From: Murphy, Mollie
To: crwispelwey@gmail.com; mossvineyards@gmail.com; candacedeloach@gmail.com
Cc: Werner, Jeffrey B
Subject: BAR # 22-12-01
Date: Wednesday, December 21, 2022 3:21:00 PM
Attachments: [image001.png](#)
[image002.png](#)

Certificate of Appropriateness Application

BAR # 22-12-01
300 Court Square, TMP 530096100
North Downtown ADC District
Owner: Eagle Tavern, LLC
Applicant: Candace DeLoach et al
Project: Exterior alterations

BAR # 22-12-01
300 Court Square, TMP 530096100
North Downtown ADC District
Owner: Eagle Tavern, LLC
Applicant: Candace DeLoach et al
Project: Exterior alterations

1 SECTION THRU PORTICO
A5 1/2" = 1'-0"

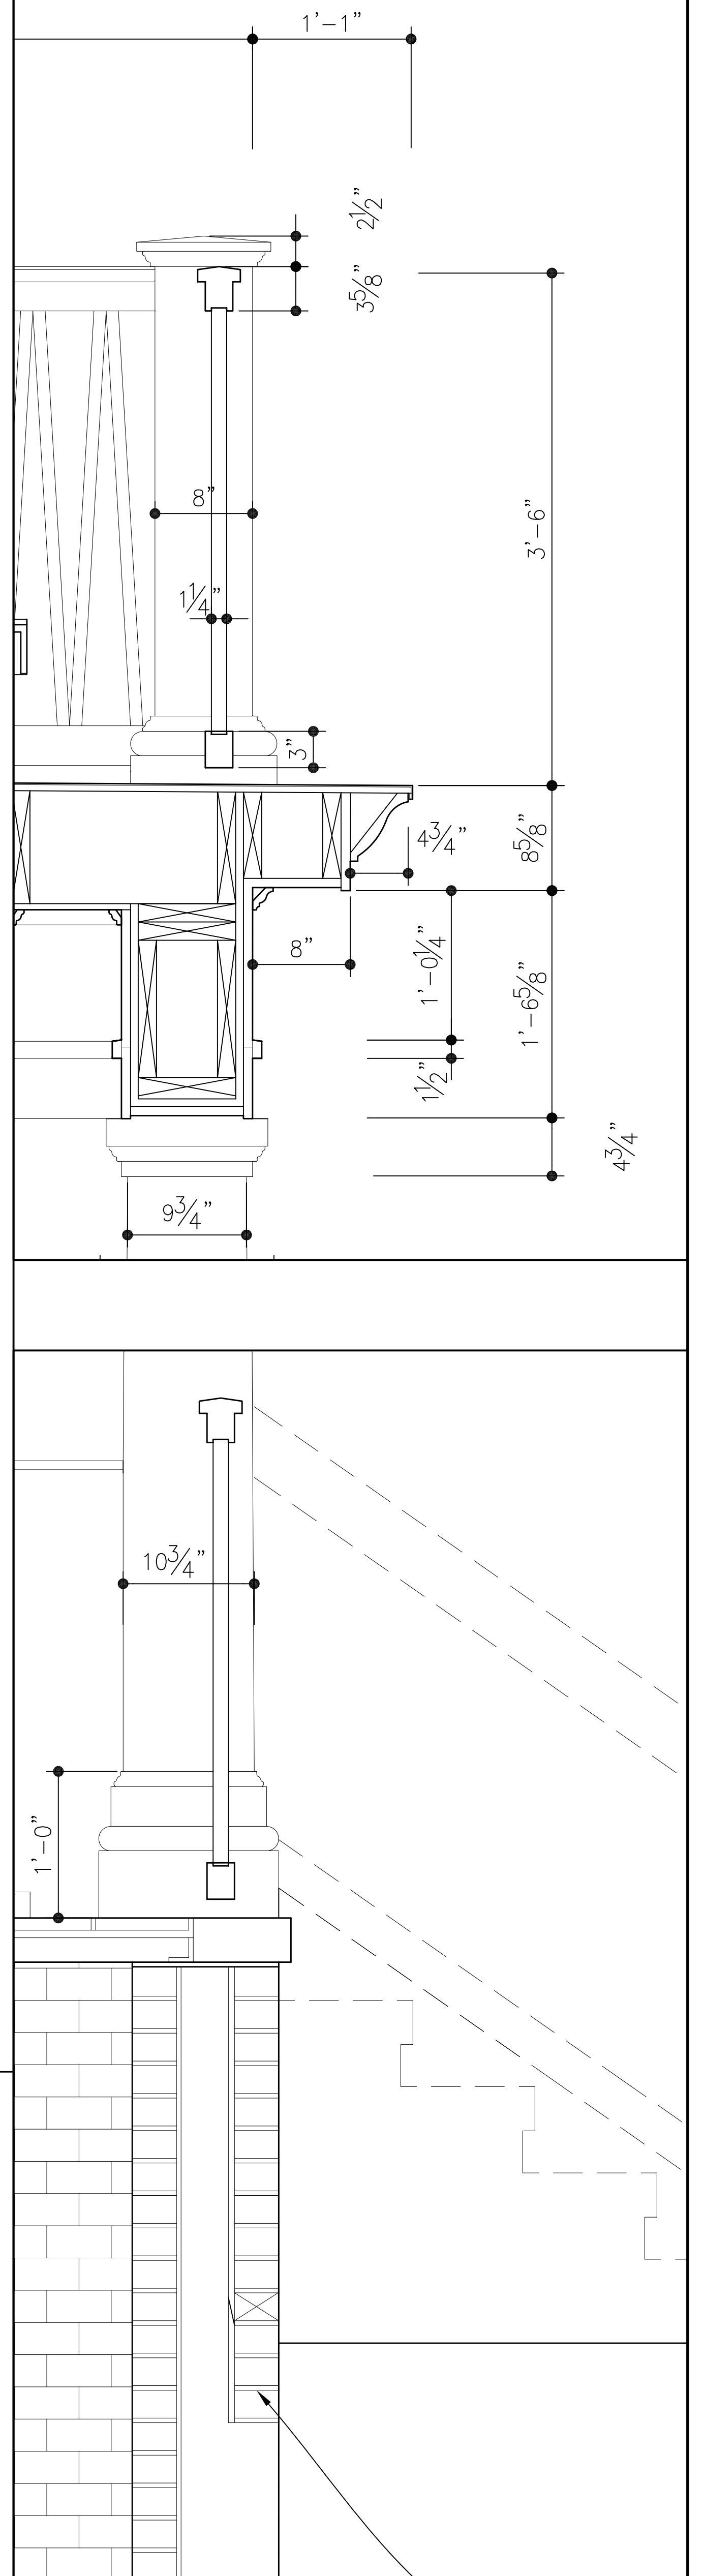
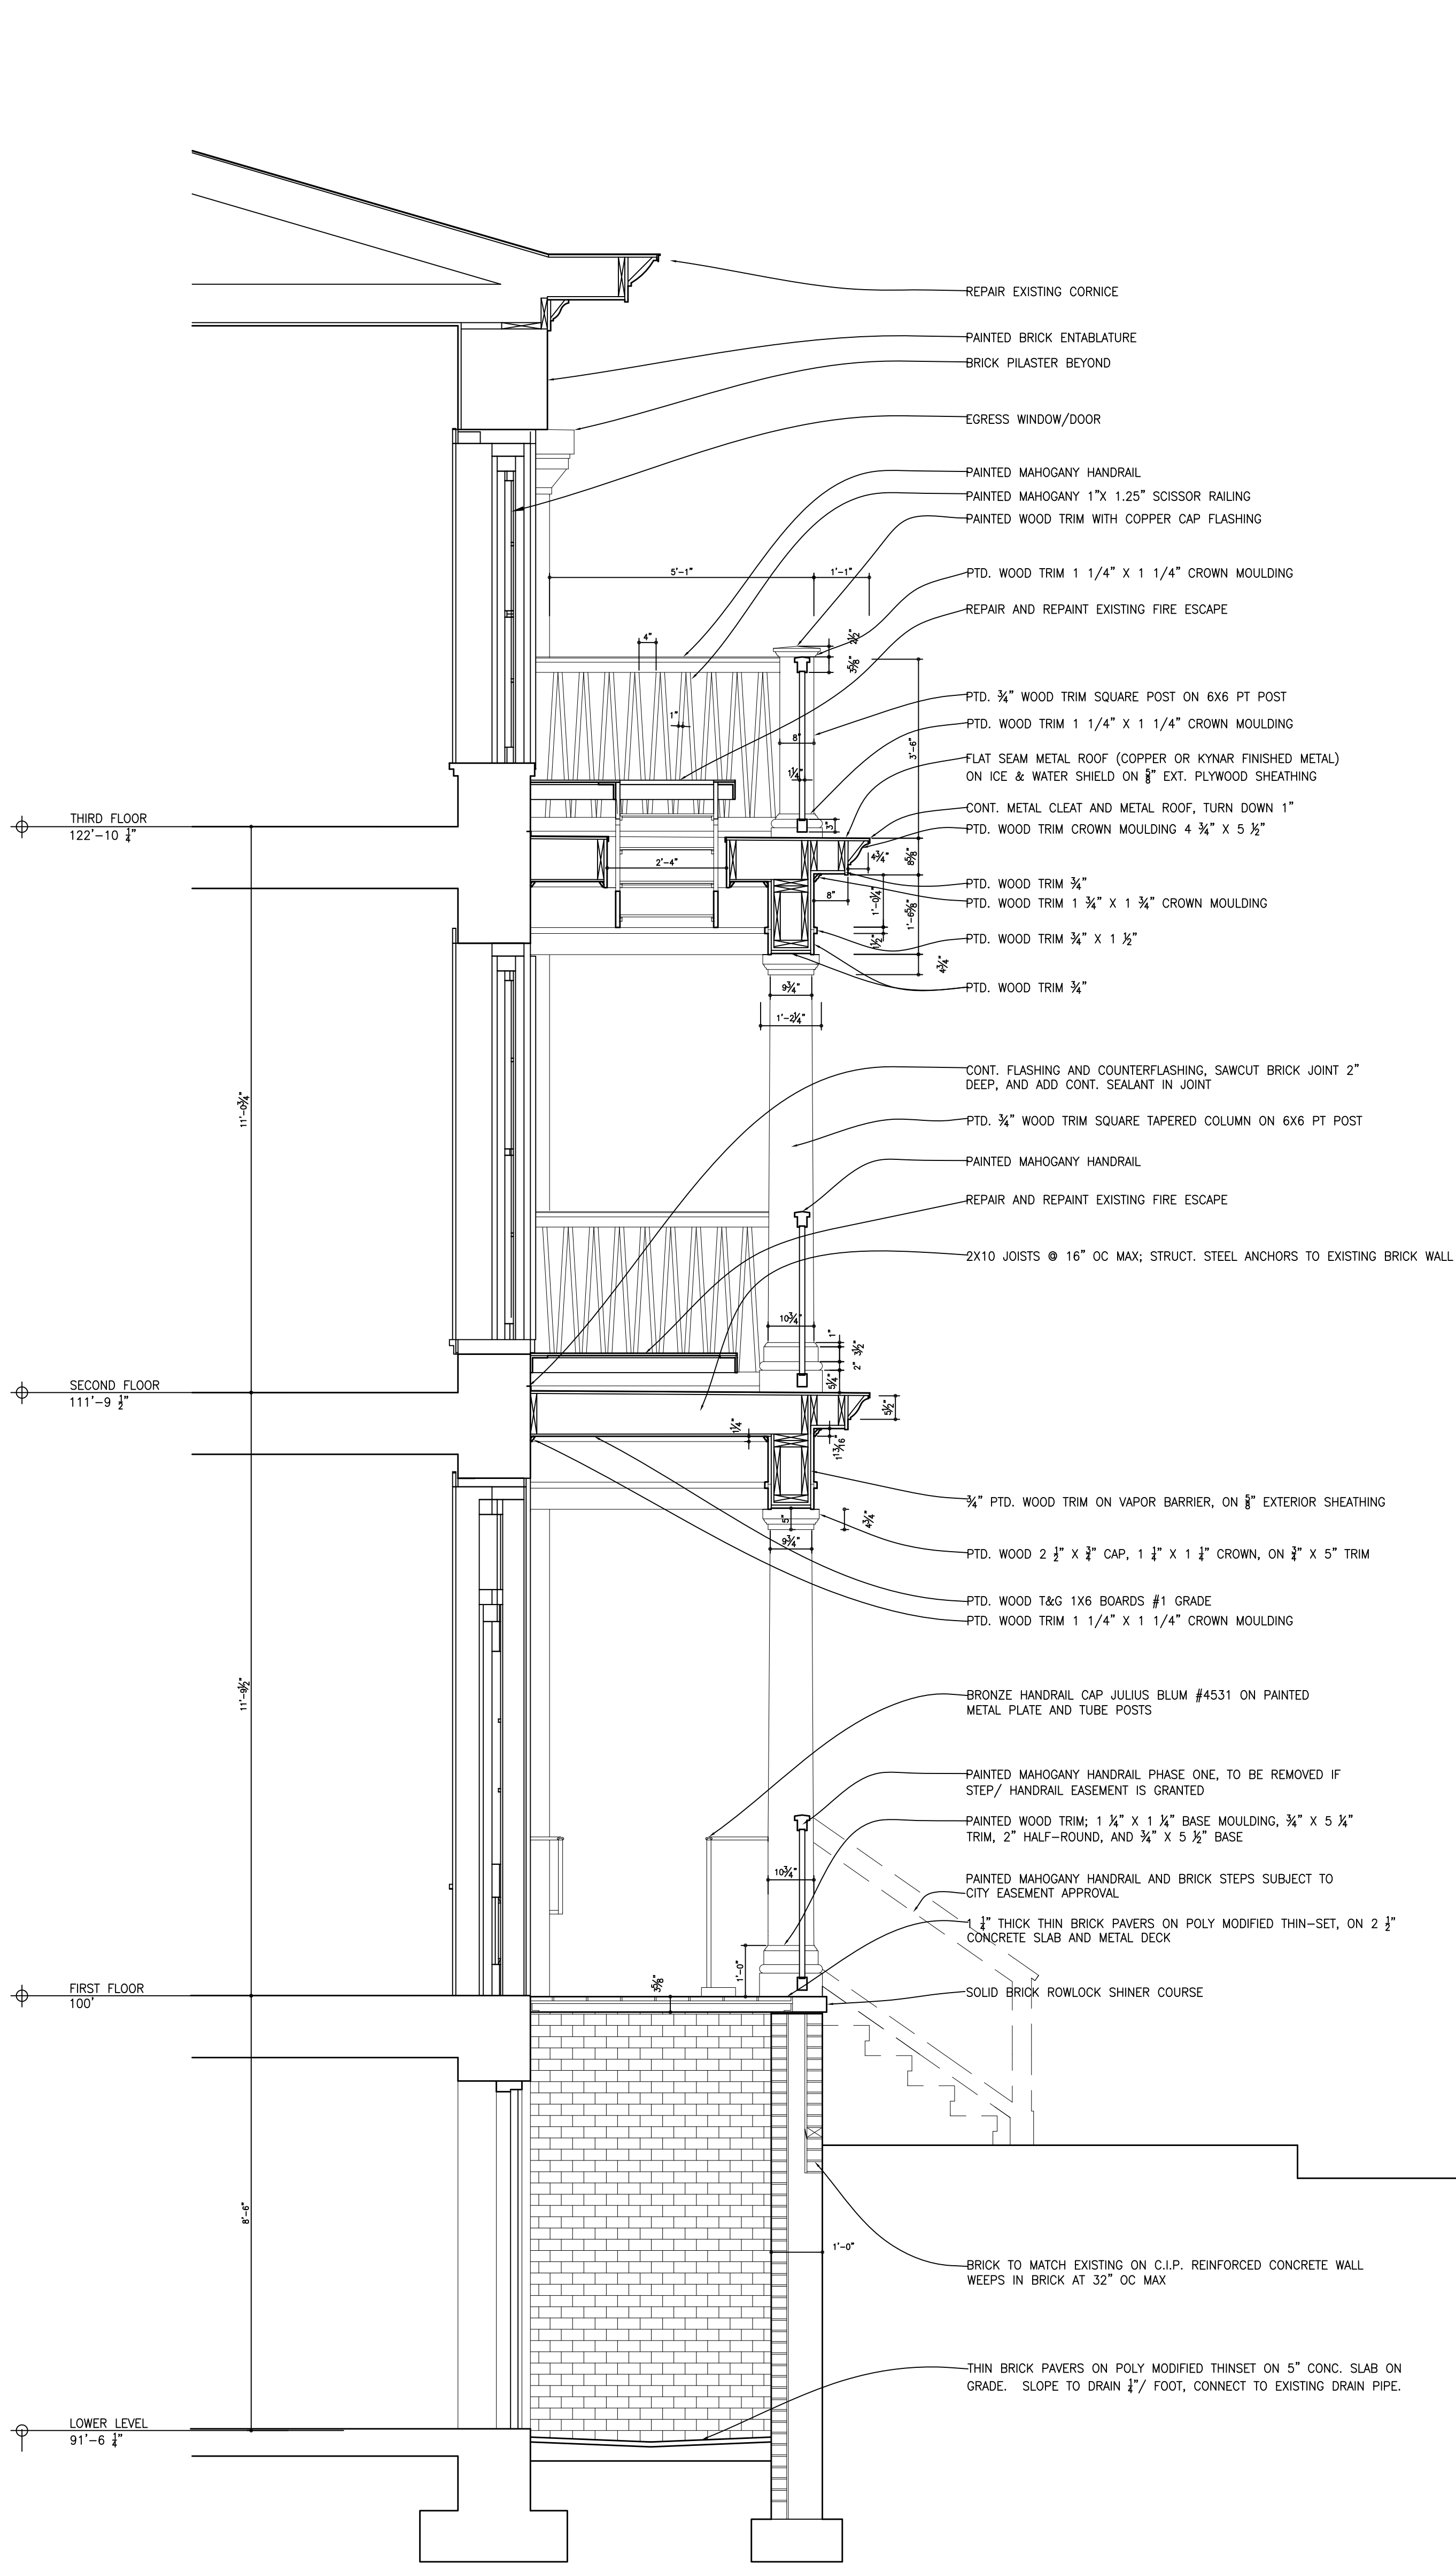
The metal fire escape will be retained and incorporated into the portico, if constructed. Second, due to possible encroachment into the City right of way, a CoA should include a condition that construction requires resolution of any encroachment. Additionally, the CoA assumes the design will not require significant alterations due to building code requirements.
